Technical Paper

RESPONSE TO CONSULTATION TO THE EMERGING STROUD DISTRICT COUNCIL DRAFT LOCAL PLAN 2019-2031

PS41 Washwell Fields

Junction Access

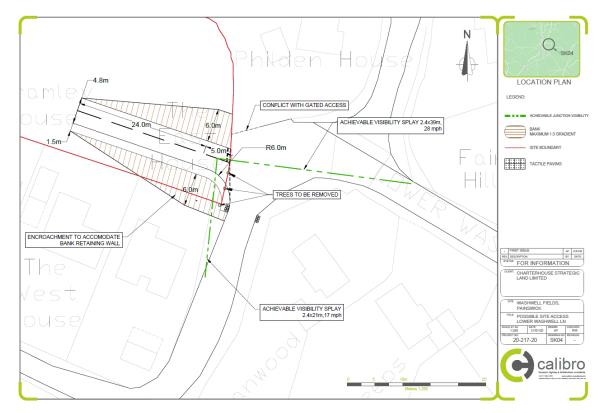
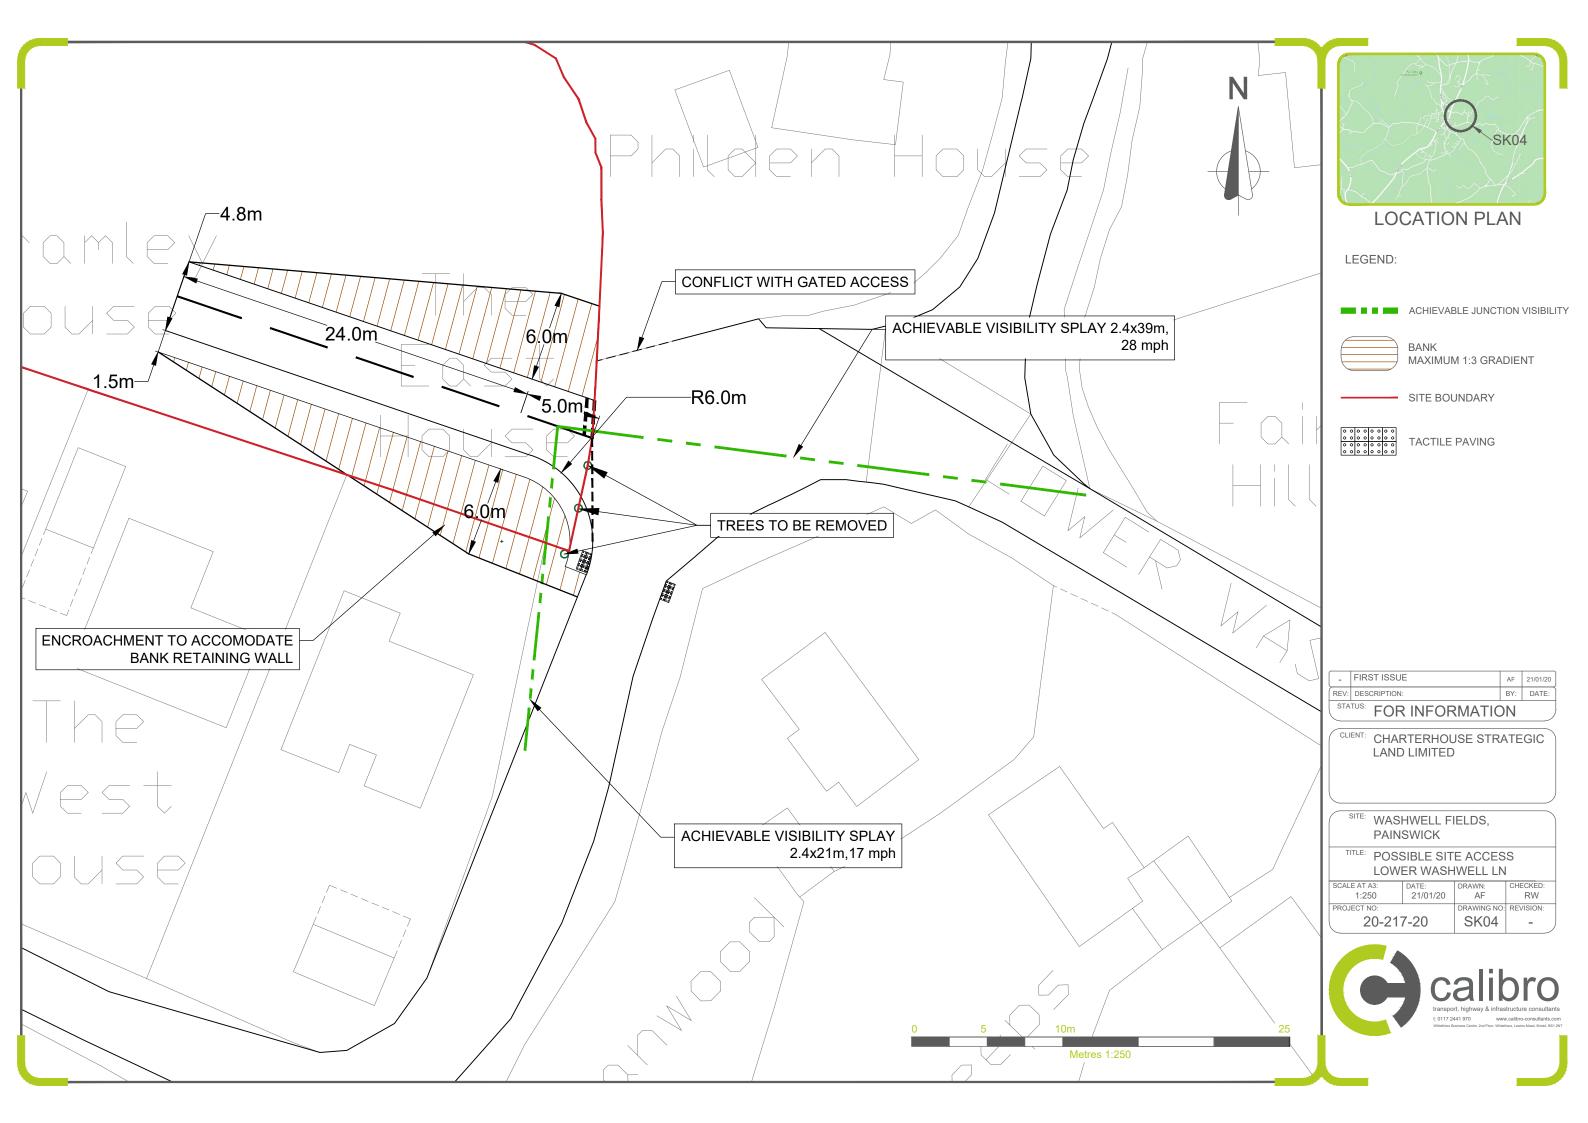
- 2.7 The above design is based on a standard priority T-junction arrangement with a 4.8-metre wide access road, which provides a proportionate specification given the scale of the proposed development in so much that it accommodates a large vehicle passing a car, in line with Figure 7-1 of Manual for Streets. Allied to this, a 1.5-metre wide contiguous footway has been shown on the western side of the access, to connect into the footway on Lower Washwell Lane.

- 2.8 As indicated in the above, an access in this location would result in the removal of the mature trees that exist on the site's frontage although it is unclear whether these are subject to Tree Preservation Orders. Furthermore, allowance for the level change between the carriageway of Lower Washwell Lane and the site confirms that a standard embankment design is not achievable without impacting on adjoining boundaries and therefore retaining wall structures would be required at additional expense.

- 2.9 The level change would also sterilise a relatively significant part of the site by virtue of the need to grade up over a distance over circa 30-metres. It is unclear this encroachment into the site would affect the development capacity of the site.

- 2.10 The above design also identifies the achievable visibility splays would be 21-metres to the west and 39-metres to the east, from a 2.4-metre setback, whereas the posted 20mph speed limit would suggest a requirement of 25-metres. Indeed, the achievable visibility splays are commensurate with approach speeds of 16mph and 28mph, respectively. For the avoidance of doubt, on-site observations suggest broad correlation between vehicle speeds and the posted speed limit.

- 2.11 In this way the junction would be substandard on visibility and its related impact on highway safety contrary to paragraph 108b of the NPPF.

2.12 Furthermore, it is noted that the anticipated site access would cause conflict with the adjacent access to the Philden House property and this is likely to be sufficient to cause the design to fail an independent Road Safety Audit. In this way, the proposals would give rise to an unacceptable safety risk, contrary to paragraph 108b of the NPPF.

Figure 3 – Lower Washwell Lane Carriageway Widths

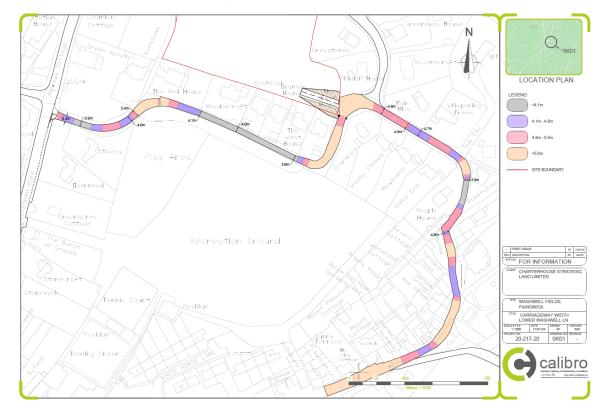
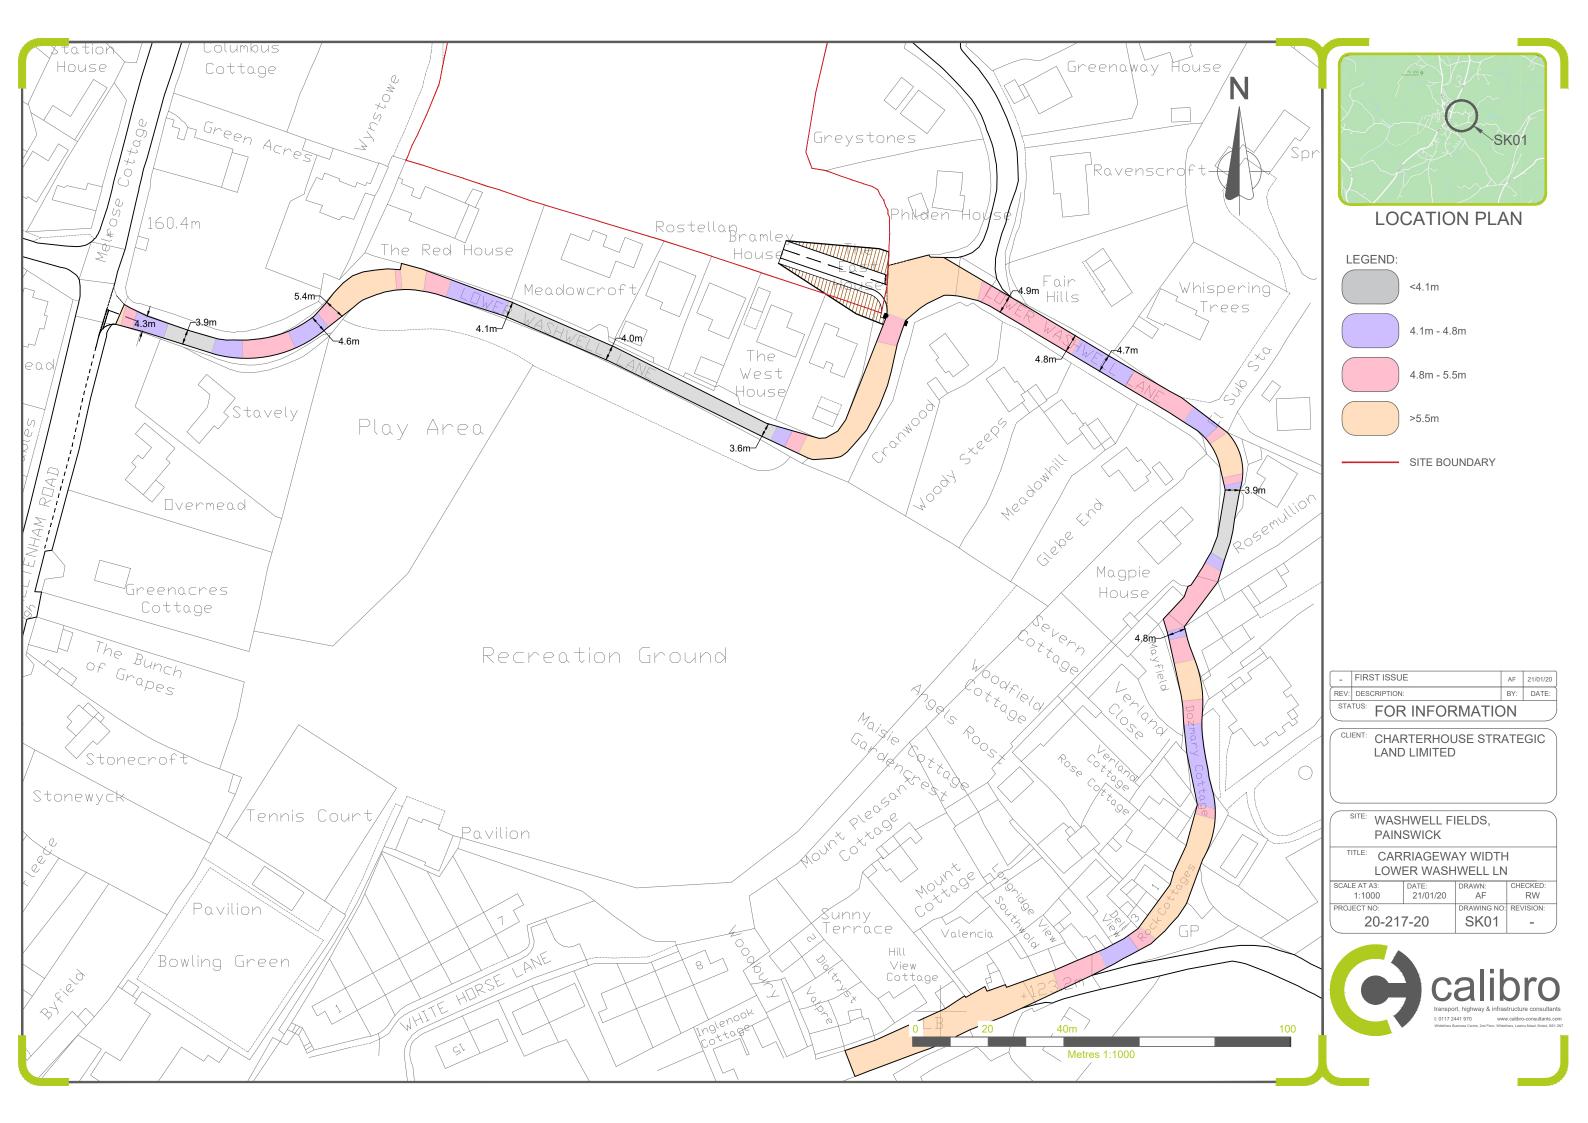
- 3.7 It is evident from the above analysis that significant proportions of Lower Washwell Lane are forced to operate as one-way by virtue of the carriageway width and it is notable that such sections are located between blind bends (refer to Paragraphs 3.9-3.11), which prohibit the ability to informally manage priority through these sections. Consequently, it is considered that there is likely to be an increase in unacceptable risk along the carriageway, particularly involving delivery and refuse vehicles (refer to Paragraphs 3.17-3.19).
- 3.8 The constraints of highway geometry are shown in the below photograph for context.

Forward Visibility

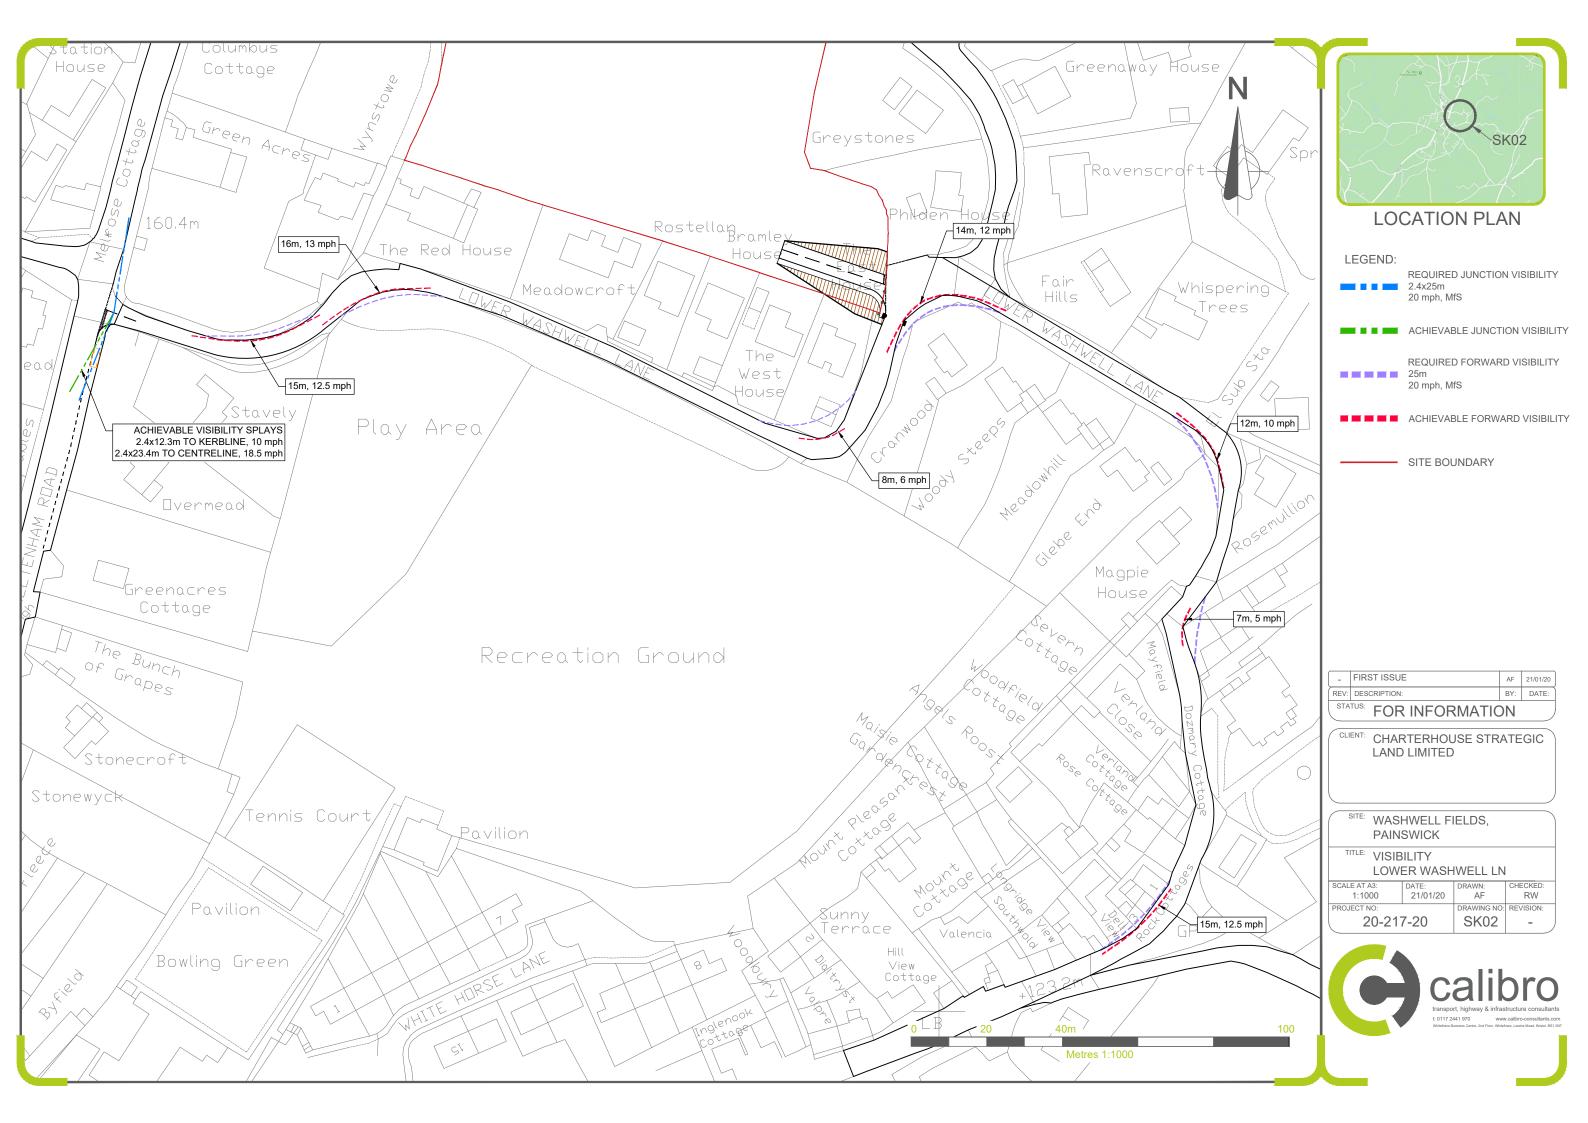
3.9 In combination with the physical extent of carriageway, Lower Washwell Lane is noted to provide limited forward visibility at the expense of highway safety risk. Indeed, this has been assessed in the below figure, which is provided at a larger scale at Appendix C, which shows that forward visibility ranges from circa 7-metres to a maximum of 16-metres; this being commensurate to vehicular speeds ranging from 5mph - 13mph respectively.

- 3.10 Consequently, it is evident that visibility is substandard and the effect of this would be either;
 - An increased risk of front-end collisions; or
 - A need for vehicles to reverse over potentially significant distances where there remains inadequate visibility and potentially in conflict with pedestrians, to a point that would allow two vehicles to pass.
- 3.11 In either of the above cases there would be an unacceptable risk to highway safety contrary to paragraph 108b of the NPPF.
- 3.12 Indeed, on-site observations have identified evidence of vehicles overrunning the highway verge, which is indicative of the metalled road surface being too narrow to accommodate existing traffic types and levels, and this is likely to have been compounded by the substandard visibility through the bends along the lane.
- 3.13 Photographic evidence of the above is shown in Figure 6 below.
